Southampton to London Pipeline Project

Responses to Written Representations -
Local Authorities

Application Document: 8.23

December 2019

Figure 2: Veteran Trees and Potential Veteran Trees Plan

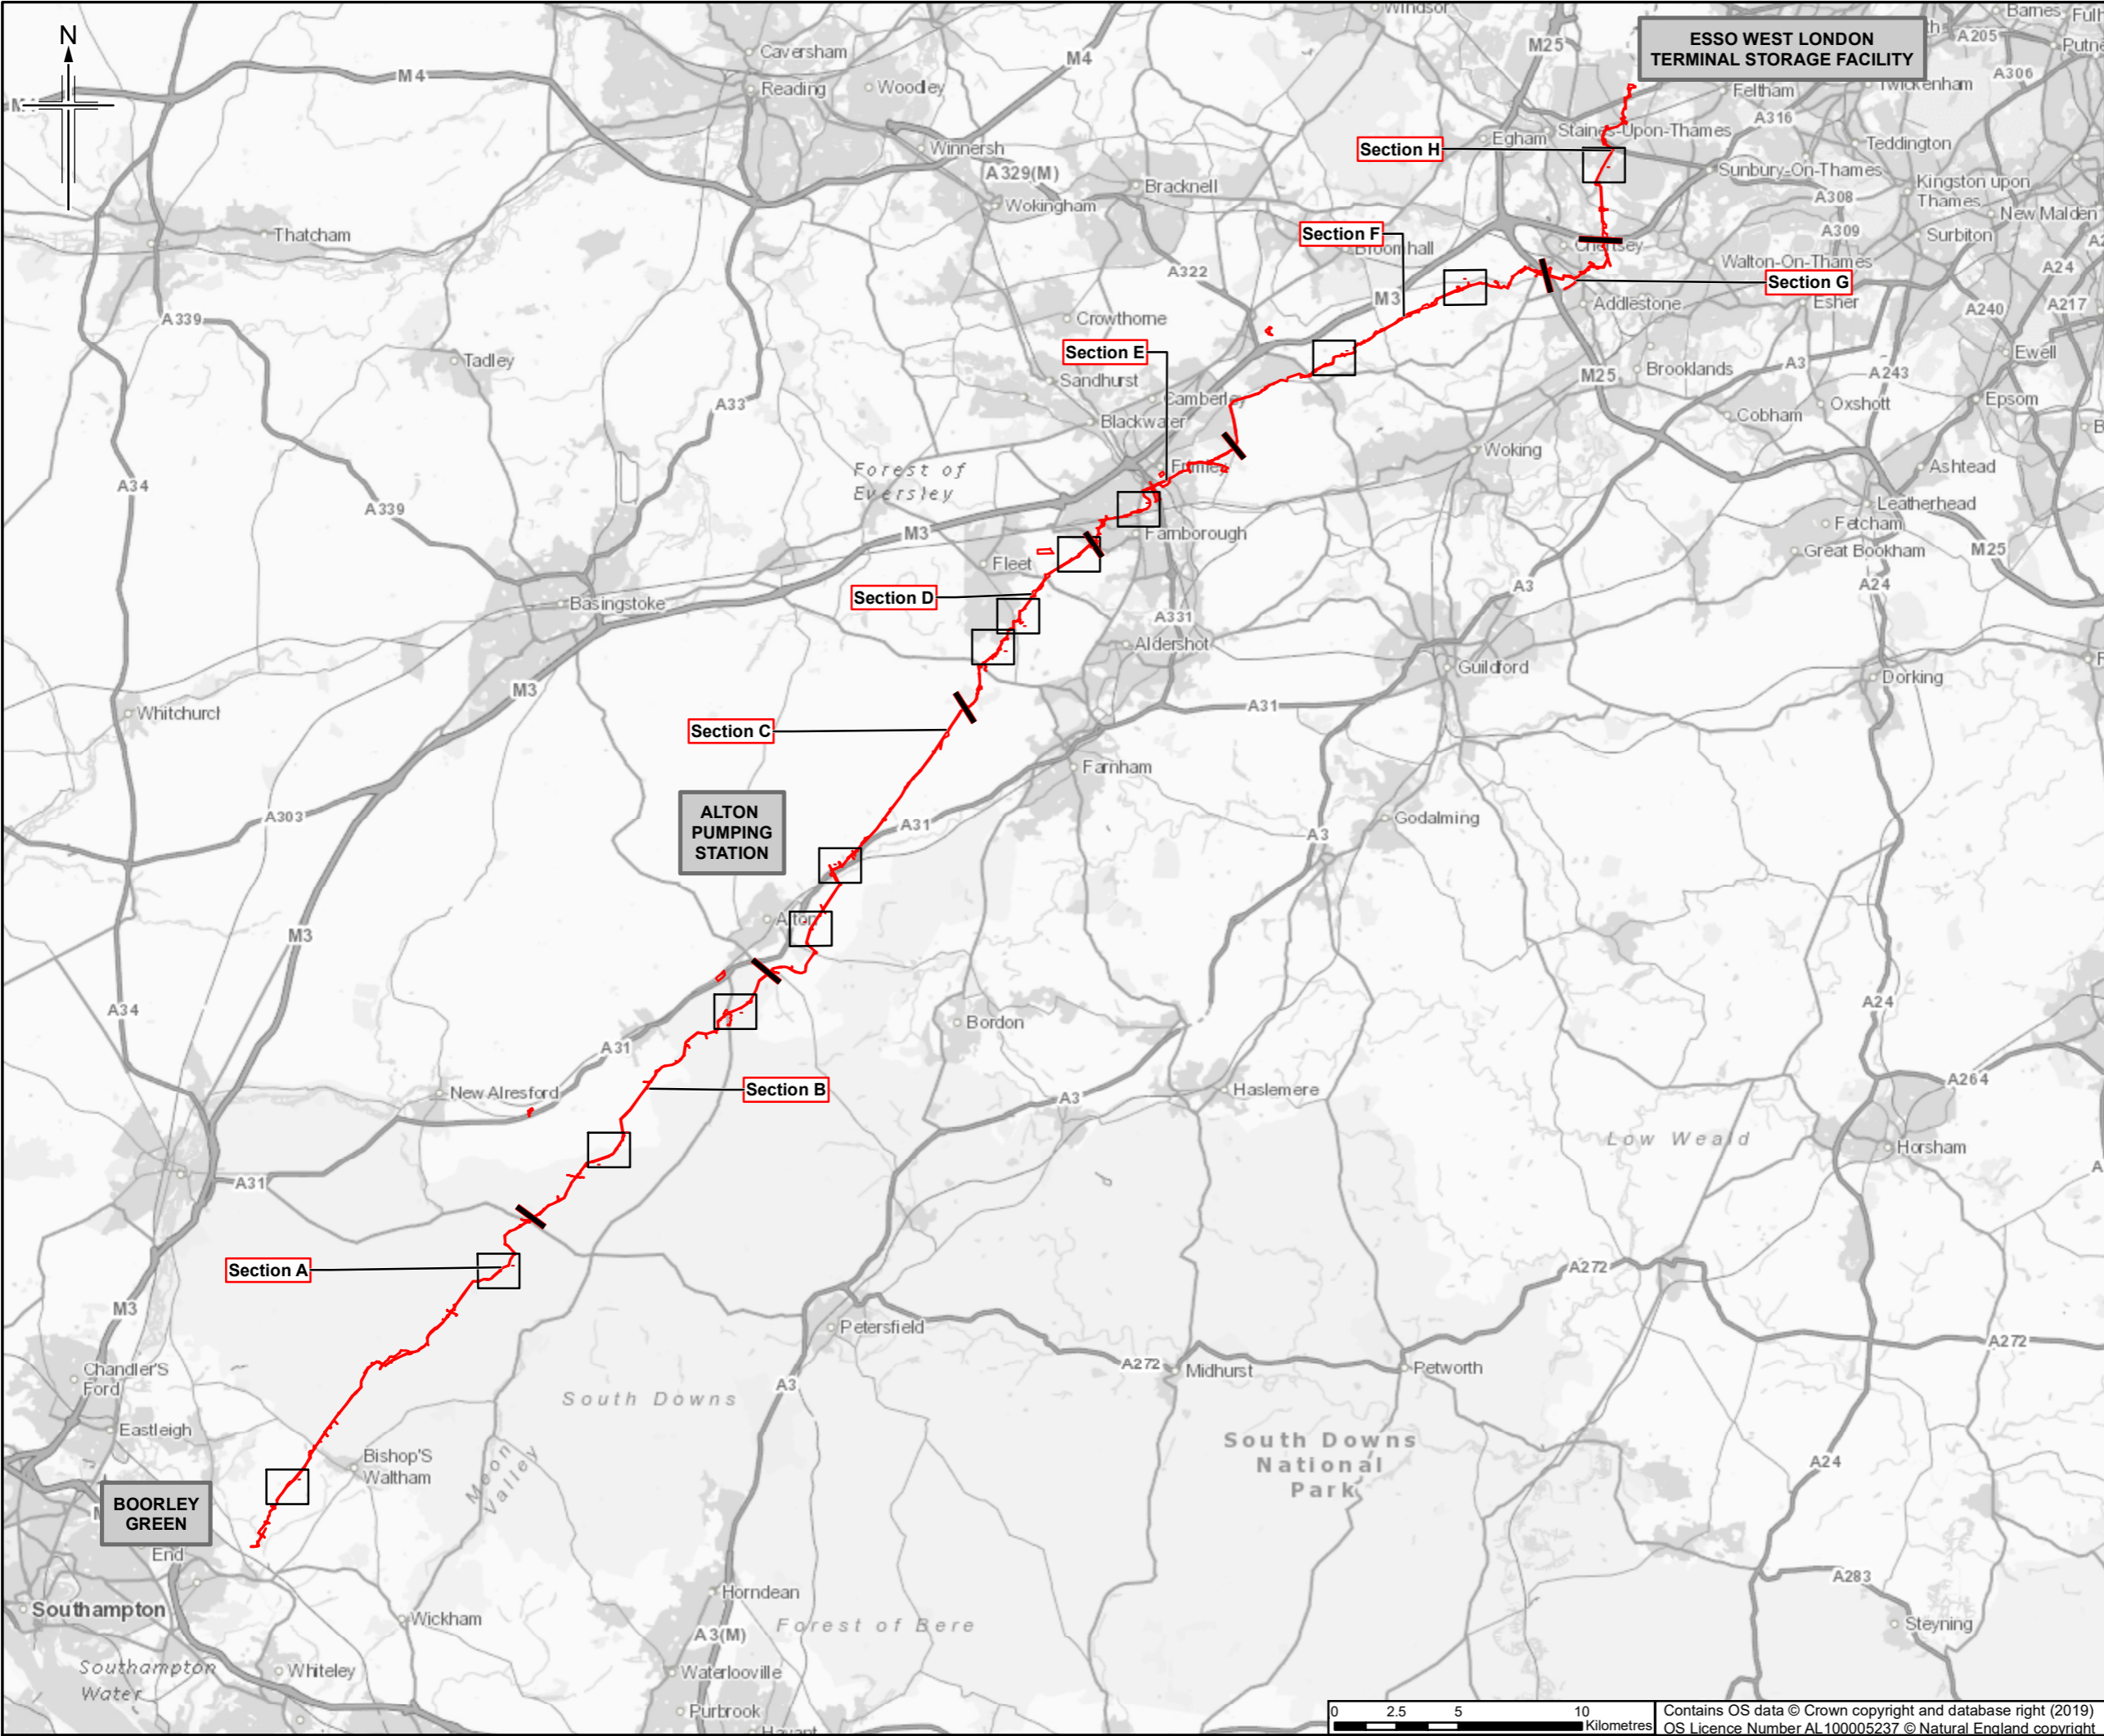
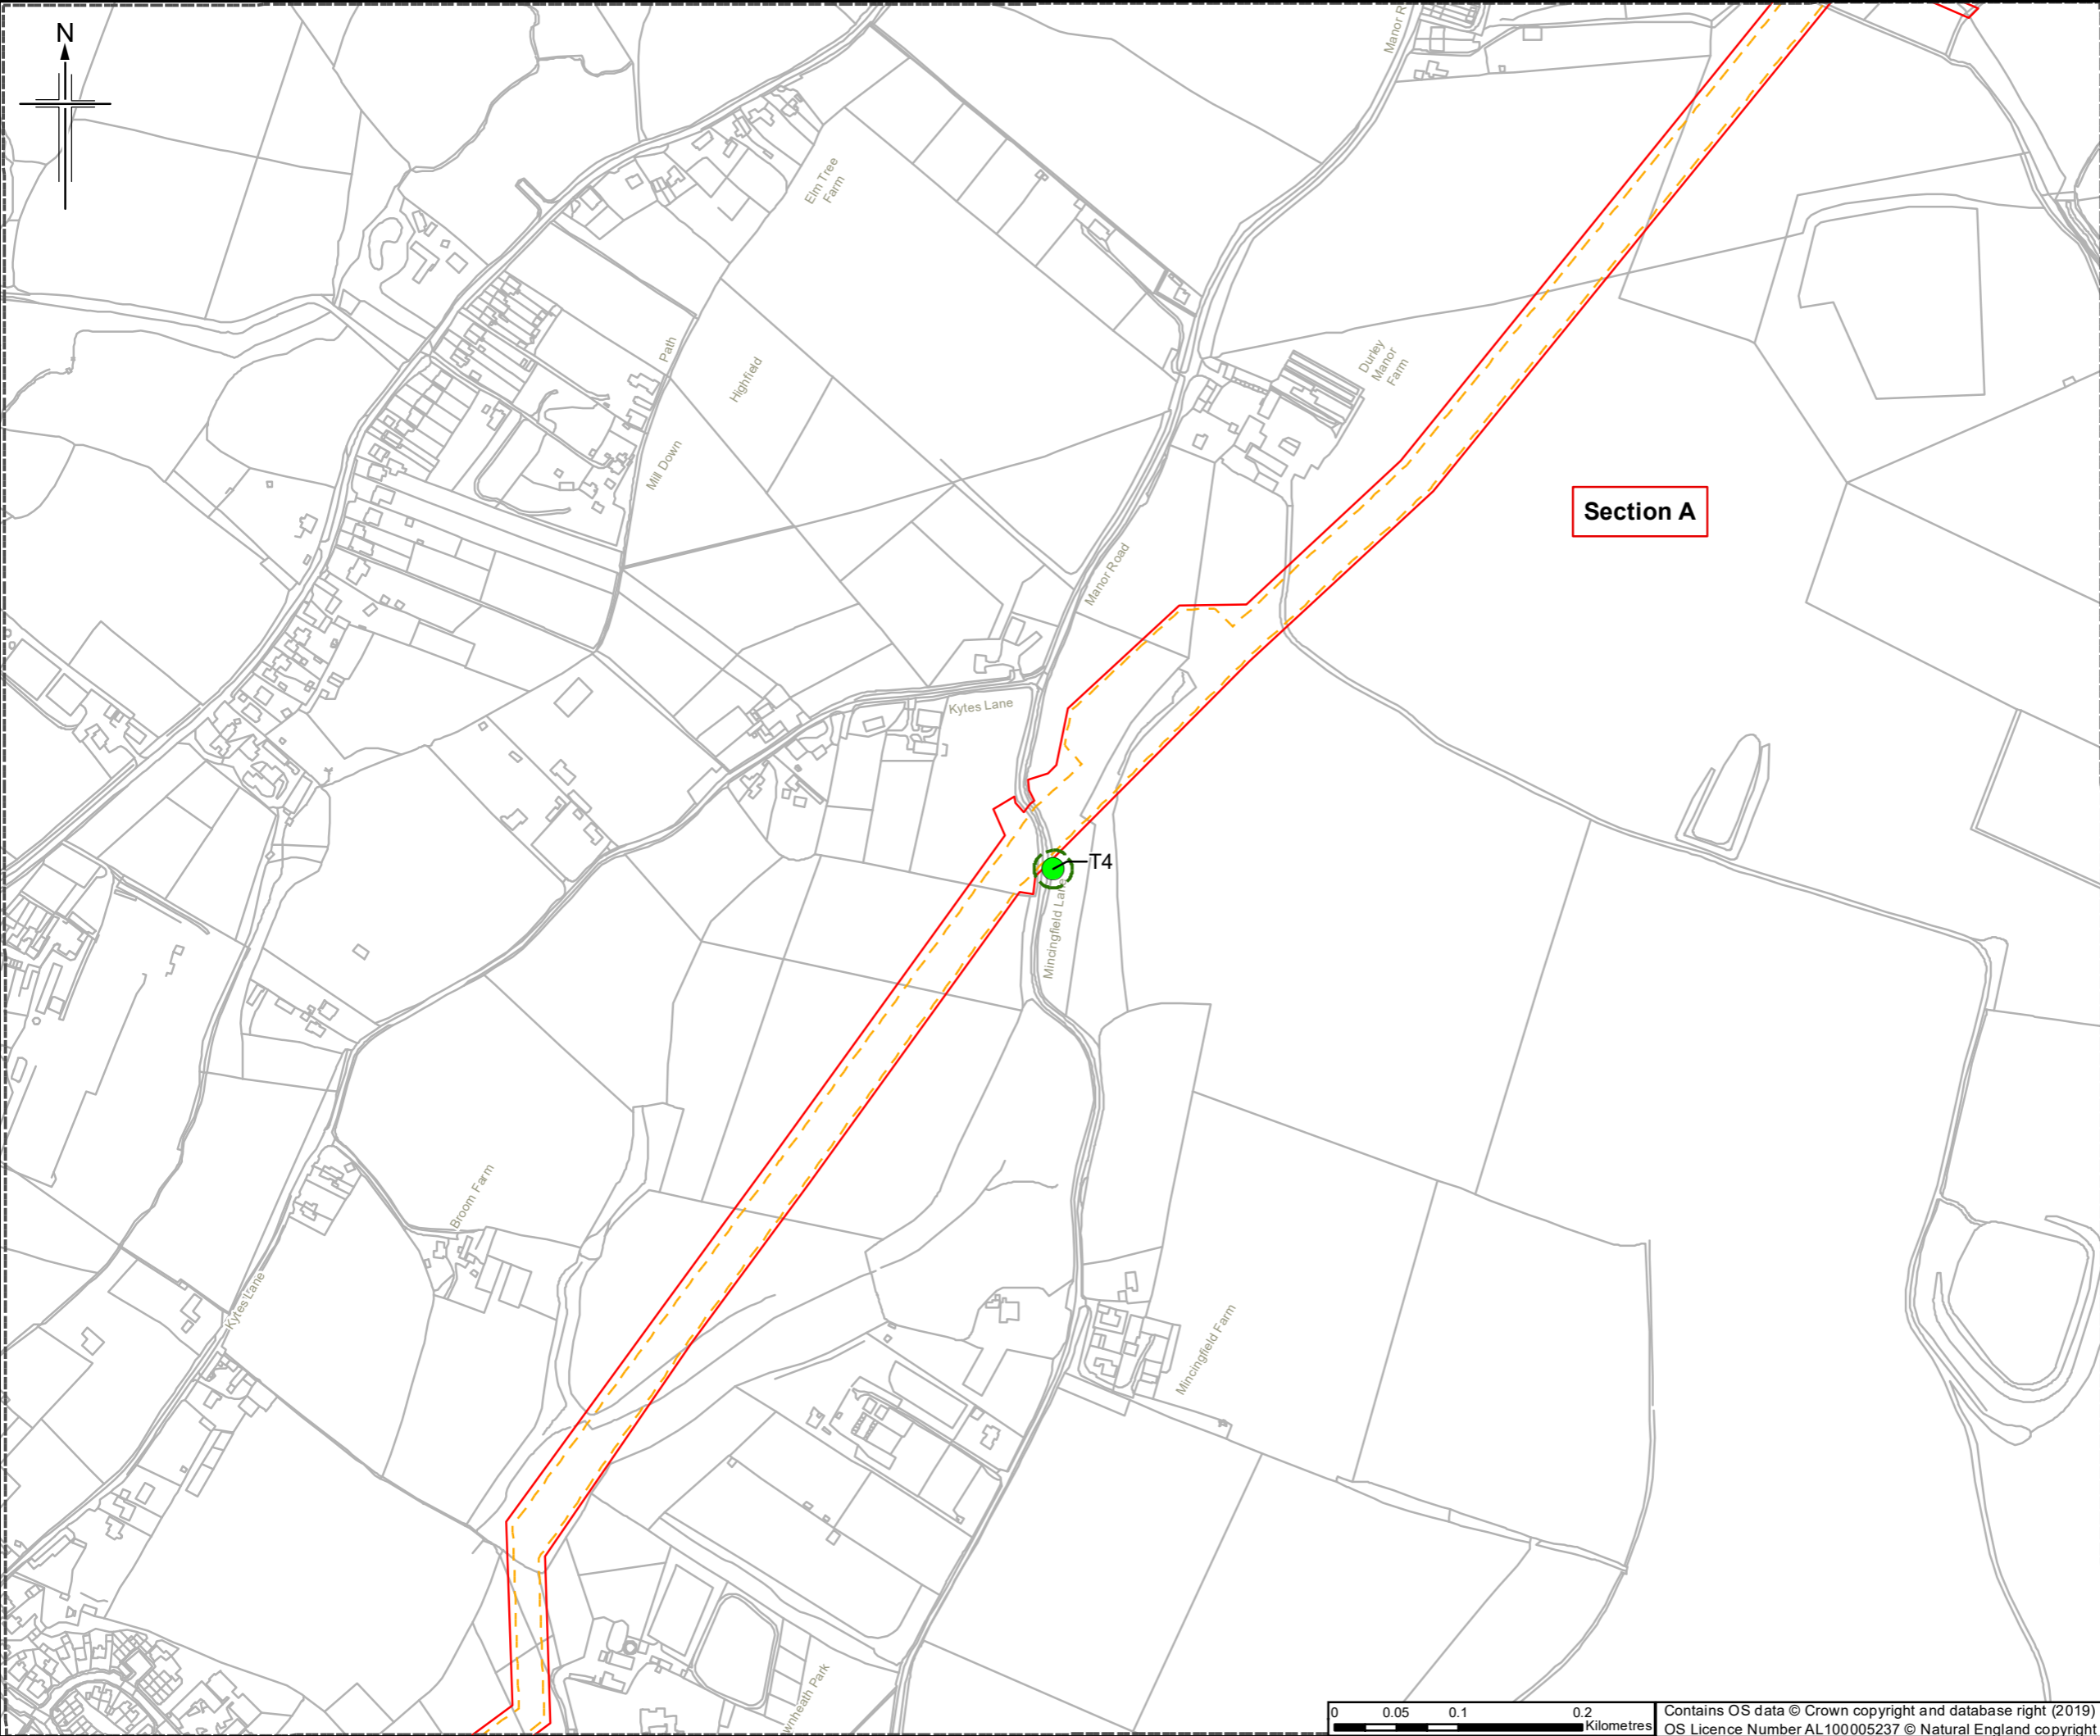
WR Para Ref	Point raised	Applicant response to point raised:
		<ul style="list-style-type: none"> reinstatement hedgerow planting would be relatively quick to establish; reinstatement tree planting would take a little longer to establish, but would have reached approximately 7m in height after 15 years. <p>It is therefore considered that, by year 15, there would be little noticeable change in the landscape character of the National Park when compared to the existing condition, and the effects on the landscape would not be significant.</p>
	<p>In its response to LV.1.25, the SDNPA furthermore requests that the A31/A32 Junction, Northfield Lane (Chawton) logistics hub be added to the list of representative viewpoints set out in the LVIA.</p>	<p>Whilst the Applicant does not consider such a representative viewpoint to be necessary, this has been prepared and is provided at Appendix 1.</p>
<p>Para 3.19 to 3.33</p>	<p>Trees and Woodland</p> <p>The SDNPA sets out concerns regarding potential impacts on, and the applicant's approach to veteran trees and ancient woodland.</p> <p>The SDNPA has requested a plan to identify which of the mitigation hierarchy measures apply to which ancient woodland.</p>	<p>The Applicant has prepared a Technical Note on Ancient Woodland and Veteran Trees (REP2-061) which sets out the approach to reduce the impacts of the project on Ancient Woodland and potential ancient woodland and Veteran Trees and potential veteran trees within 15m of the Order Limits.</p> <p>The Technical Note sets out a hierarchy of mitigation principles, ranging from the use of buffers and ground protection around trees, to the requirement for specialist construction techniques to be used for any unavoidable excavation within root protection areas. The Technical Note has regard to the joint standing advice from the Forestry Commission and Natural England (Ancient woodland, ancient trees and veteran trees: protecting them from development, 2018) when developing the hierarchy of mitigation principles, with avoidance of works within 15m of the edge of ancient woodland and 15m from the stems of veteran trees recommended where practicable.</p>

WR Para Ref	Point raised	Applicant response to point raised:
		<p>Natural England has signed a SoCG with the Applicant (REP1-005), Section 3 of which sets out agreement on matters including:</p> <ul style="list-style-type: none"> • avoiding classified ancient woodland and reducing impacts on potential ancient woodland; • the mitigation proposed in Chapters 7 (Application Document APP-047) and 16 (Application Document APP-056) of the ES; and • working methods in relation to ancient woodland and veteran trees. <p>The Forestry Commission has signed an SoCG with the Applicant (REP2-025), Section 3 of which sets out agreement on matters including:</p> <ul style="list-style-type: none"> • that the proposed approach to mitigating effects on Ancient Woodland, potential ancient woodland and veteran trees, as described in the ES (Application Document APP-056) and the further information included in the Ancient Woodland and Veteran Trees Technical Note (REP2-061) are appropriate; • that appropriate measures have been taken to identify all areas of Ancient Woodland, and areas of Potential Ancient Woodland that do not appear on Natural England's Ancient Woodland Inventory; and • that the Order Limits avoid all areas of existing classified Ancient Woodland. <p>In addition, the Applicant has prepared a plan showing the locations of Ancient Woodland, potential ancient woodland, Veteran Trees and potential veteran trees (see Figure 1 and 2 appended to this document).</p>
